ADDENDUM NO. 3

SOLICITATION NO. 202583 – SUNSET ROAD: SILVERBELL ROAD TO INTERSTATE 10

TYP. DECK SECTIONS
SUNSET ROAD - SEGMENT 1
SILVERBELL RD. TO I-10
PROJECT NO. 4RTSUN

STAY-IN-PLACE DECK FORM DETAILS
SUNSET ROAD - SEGMENT 1
SILVERBELL RD. TO I-10
PROJECT NO. 4RTSUN

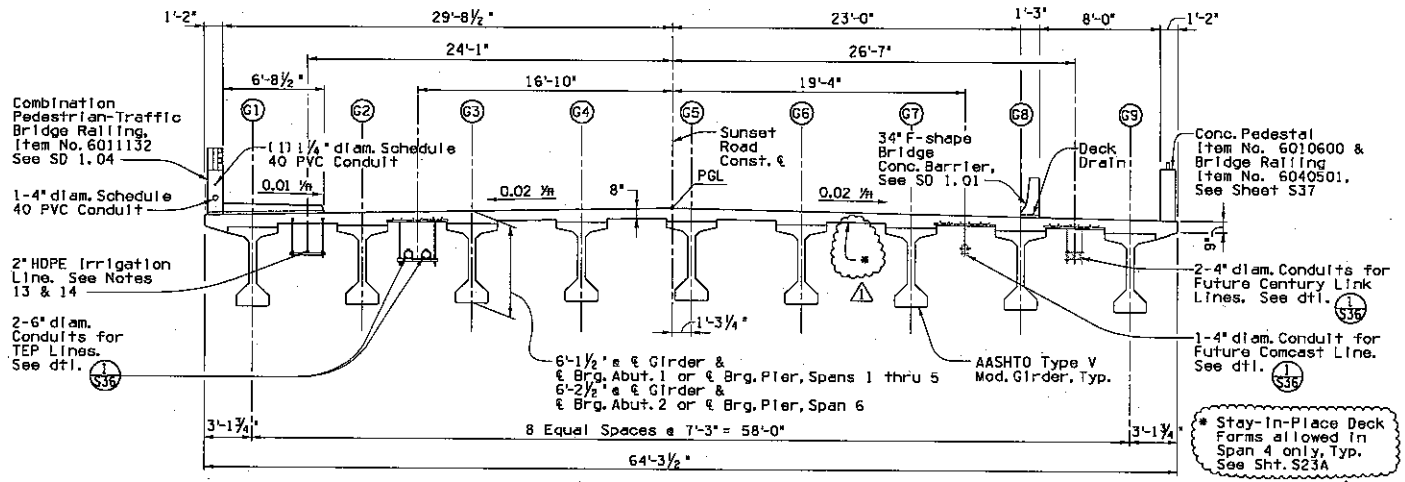
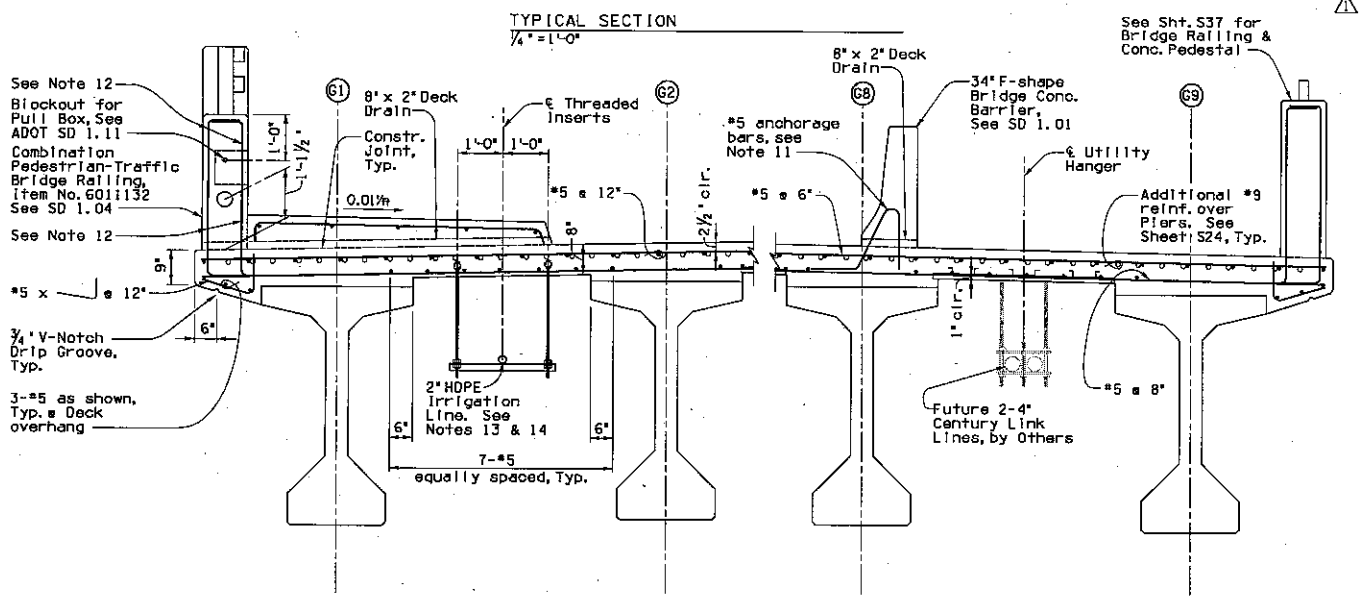
Q) Where there is restricted access due to the wetlands under span 4 (between piers 3 and 4), will stay in place deck forms be allowed?
A) Yes for that span only. Please see revised Sheet S23-Page 92 and new Sheet S23A-Page 92A Attachment 1 (2 pages)

Q) Drawing Sheet 92 Identifies 1-1/4" PVC electrical conduit installed in the combination pedestrian and traffic Bridge rail barrier wall. What bid Item is this to be under?
A) See Sheet S23-Page 92 note #15. Conduits are included in pay item 6011132.

Q) Drawing sheet 92 identifies installing a Pull Box ADOT SD1.11 in the combination pedestrian and traffic Bridge rail barrier wall. How many of these are to be installed and where?
A) The Pull / Junction Box shall be spaced per code with one at the center of the bridge and one 75 feet from each end for a total of three Pull / Junction Boxes

Q) Drawing Sheet 124 identifies Bid items #7320475 for Type I Junction Box and Bid Item #7320476 for Type II Junction Box. These bid items are not on the bid schedule. How many of

each type of Junction box are to be installed on the bridge barrier wall? Where are these boxes to be install along the Barrier Wall?
A) Junction Boxes shall be used for the purposes of providing Pull Boxes as shown on Sheet S23-Page 92. Cost of Junction / Pull boxes shall be included in pay item No. 6011132.

14. For 2" HDPE Irrigation line hanger detail, See Irrigation Plans.
15. All cost associated with the construction of the Combination Pedestrian Traffic Bridge Railing, including conduits, pull boxes, sidewalk, railing, dado, anchorage bars and deck drains are included in pay item No. 6011132.

EROSION AND POLLUTION CONTROL PLAN
STA. 68+27 TO STA. 76+00
SUNSET ROAD - SEGMENT 1
SILVERBELL RD. TO I-10
PROJECT NO. 4RTSUN

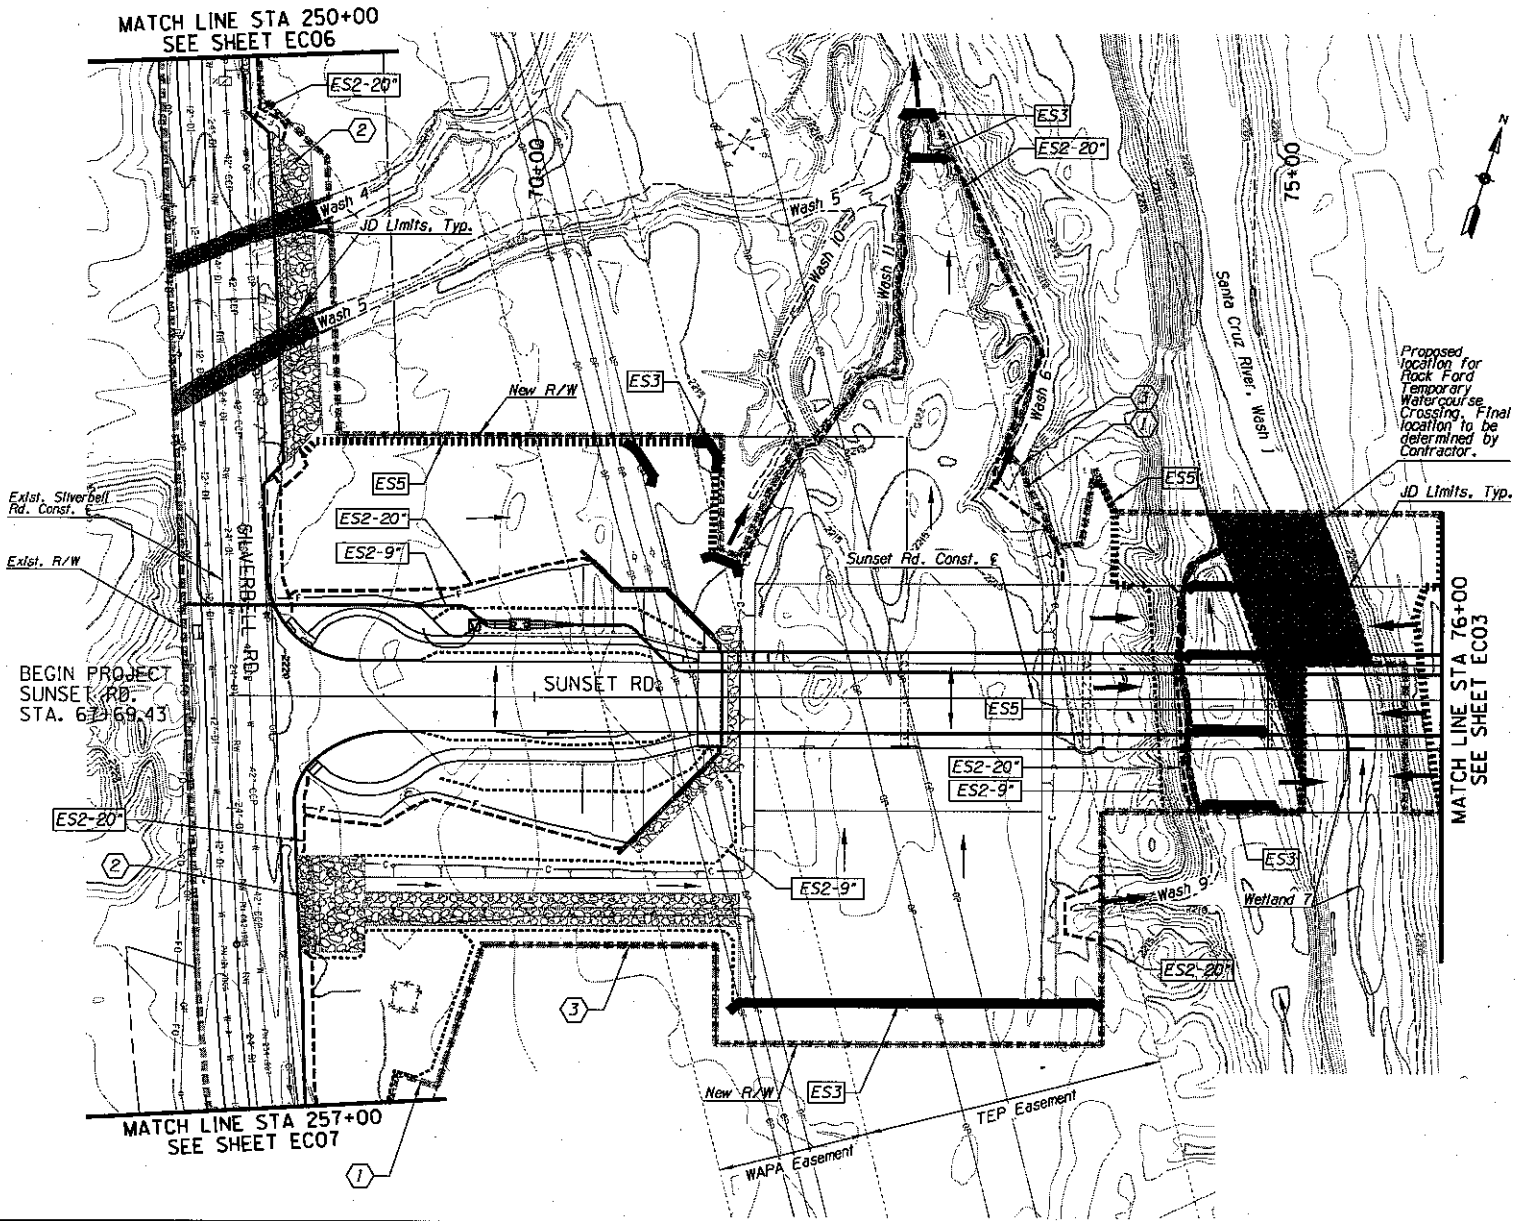
Q) Is there an electronic version of the disturbance limits?
A) Sheet EC02-Page 13 through Sheet EC07-Pages 140 depict the disturbance limits. A pdf version of the disturbance of those sheets is attached. Attachment 2 (6 pages)
